**Subject:** This amendment describes modifications to the B111 Construct Outpatient Mental Health Clinic construction documents prior to solicitation. There have been several changes made to the specifications but no changes to the project drawings.

**Project:**  
Expand/Construct  
Outpatient Mental Health Clinic  
Building 111 Addition  
Veterans Affairs Medical Center  
St. Cloud, Minnesota

**VA Project No.:** 656-341

**EXPAND/CONSTRUCT OUTPATIENT MENTAL HEALTH CLINIC  
IMPACT BUILDING—REVISED RAMP & SITE PLAN  
AMENDMENT 4 - REVISION**

SHEET  
111-  
AS107  
REVISED

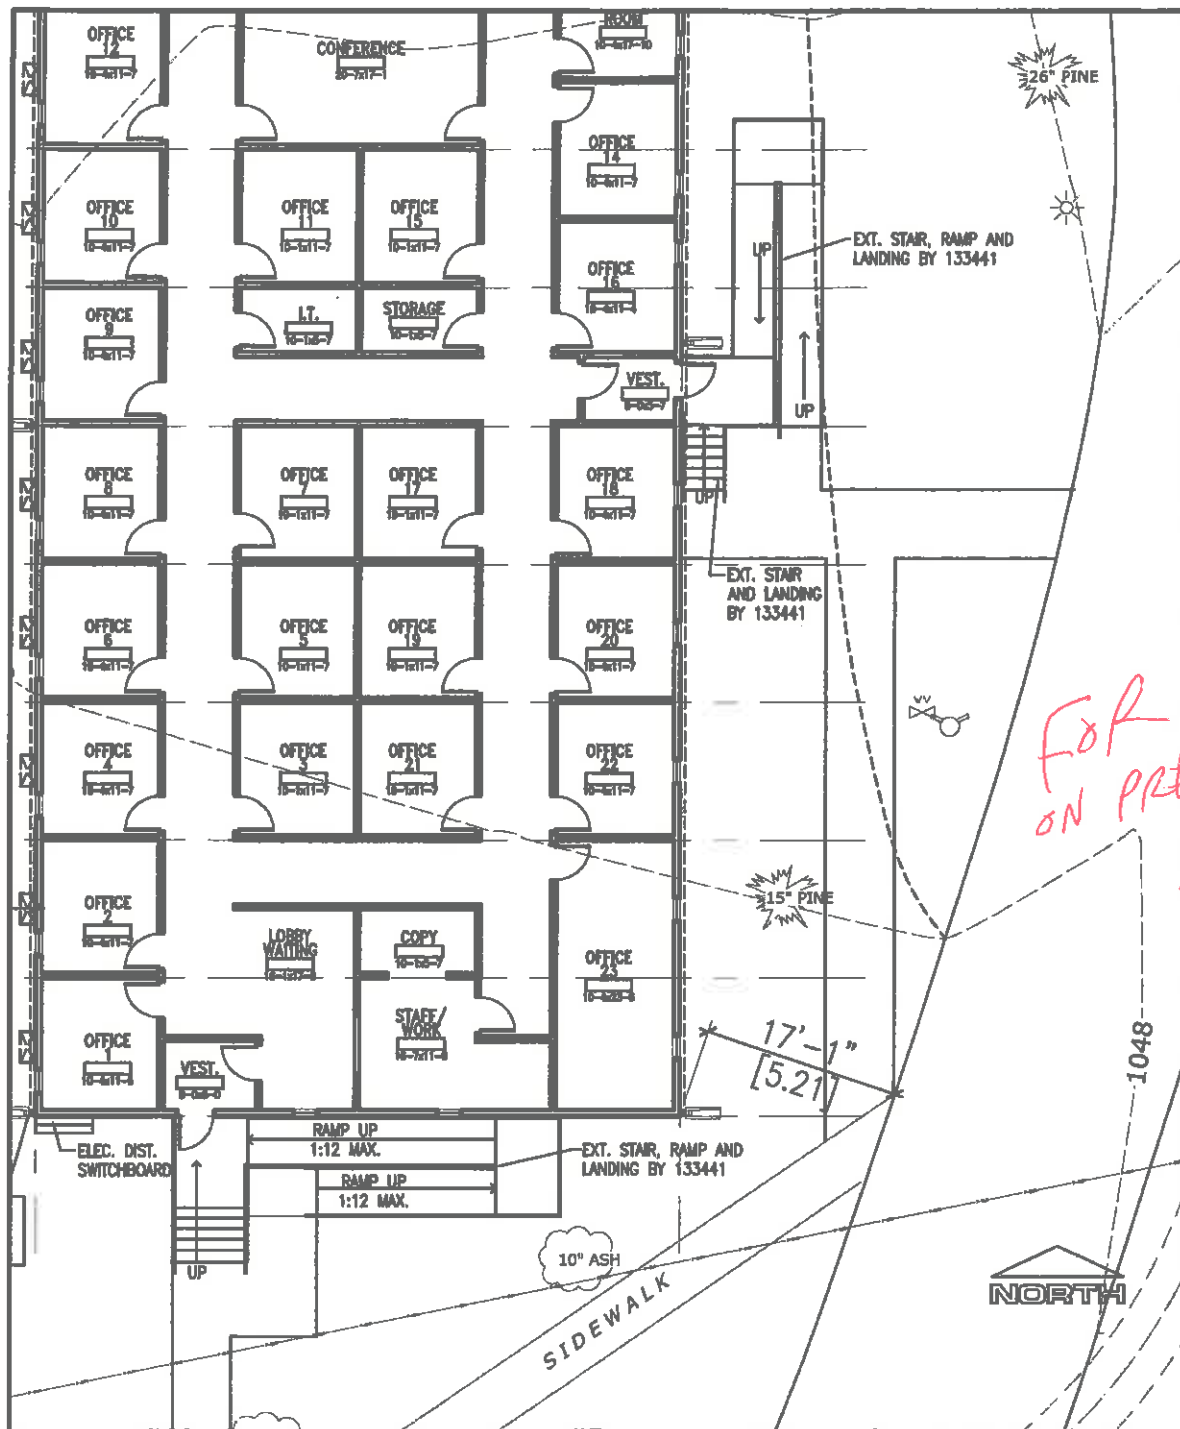
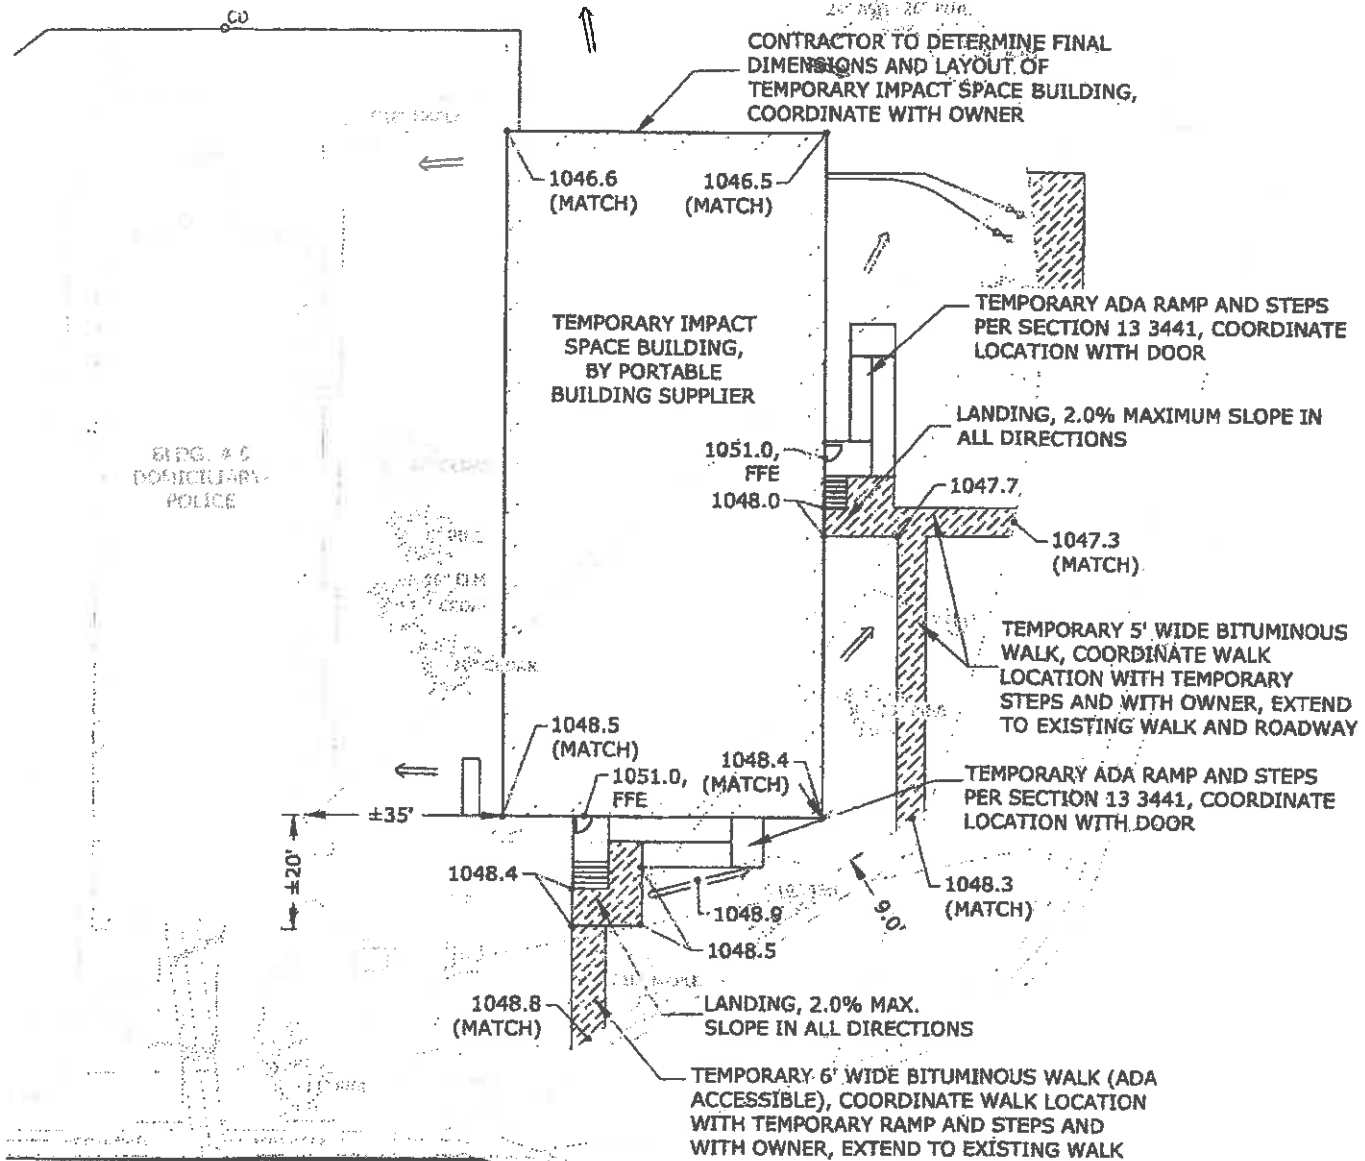
**Sheet 111-AS 107:** East exit from Temporary Building: Change to a stairs and ramp system, similar to that shown on the South Entry. Note: The amount of risers may increase as indicated and the length of the ramp shall be adjusted to accommodate the longer drop/ run of the ramp if required by the Modular manufacturer/contractor to meet site requirements. See two enclosed drawings included in this Amendment 4—drawing sheet 111-AS107 Revised & Civil Exhibit, modifying Civil Sheet 111-CS302 & 111-CS102, which will indicated ramps/stairs at both entrances, as well as landing concrete at stairs and base of ramp.

**Answer:** A ramp will need to be added to the east stairs of the impact (temporary) building so that two accessible egresses service that building. The impact building as shown on Drawing AS107 is suggested but the actual building layout may differ based on modular building availability. See Foss Amendment No. 4 and drawings.

PARTIAL BUILDING/RAMP PLAN & SITE PLAN SHOWN FOR  
ADA & SITE CLARITY; THIS DOCUMENT SHALL AMEND ALL  
LOCATIONS SHOWN WITHIN THE CONSTRUCTION DOCUMENTS

SHEET  
111-  
AS102  
REVISED

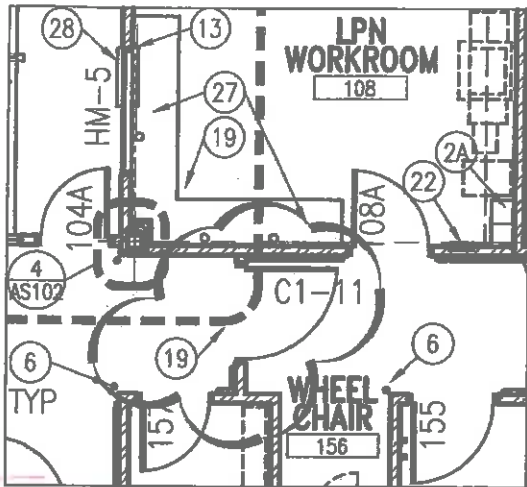
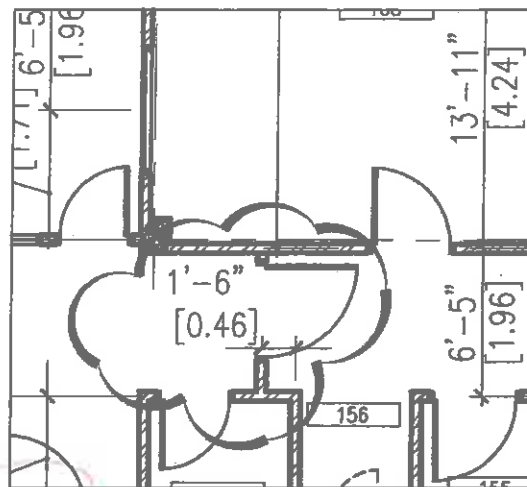
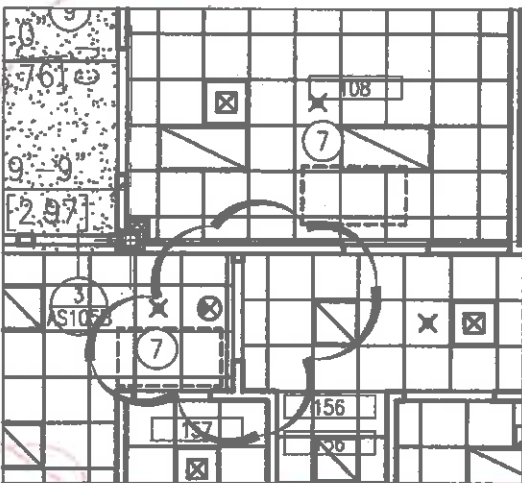
Detail 1/AS102, Door C1-11: Swing of door shall be reversed, relocated wall & handrails modified as indicated on Sheet 111-AS102 attached.

Detail 1/AS102B, Door C1-11; Revise location of wall in clouded area as indicated on Sheet 111-AS102 attached.

Detail 1/AS105B, Door C1-11; Revised reflected ceiling plan as indicated on Sheet 111-AS102 Amendment 5 attached. Note: this change impacts the location of, and clearance for an HVAC Terminal Unit above the ceiling—mechanical shall make and adjustment to duct and terminal unit as required for the relocation and configuration of the door C1-11.

**Answer:** The Fire Protection Engineer requires that Door C1-11 on Drawing AS102 will have to swing away from Waiting Room 103. Foss will provide more detail for construction.

NOTE: PARTIAL BUILDING PLANS REVISING DOOR C1-11 AND SURROUNDING AREA; THIS DOCUMENT SHALL AMEND ALL LOCATIONS SHOWN WITHIN THE CONSTRUCTION DOCUMENTS
